4PID Ad hoc – Review

IEEE 802.3: 4PPOE Task Force
4PID Ad Hoc

George Zimmerman, Ph.D.
CME Consulting

Option comparison (darshan_11)

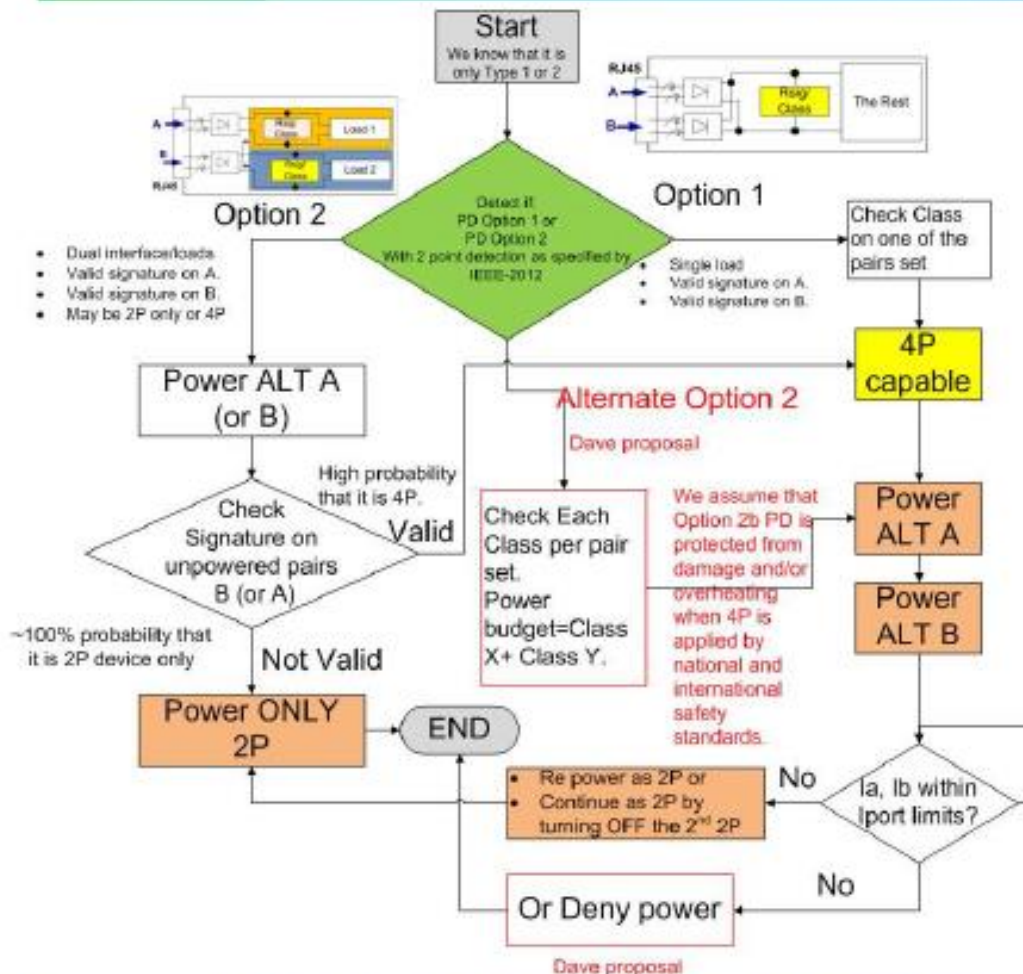
Green decision block and Option 1 branch appear agreed, assuming "Power ALT A" & "Power ALT B" blocks are a single state, not a sequence

Alternative Option 2 is marked red.
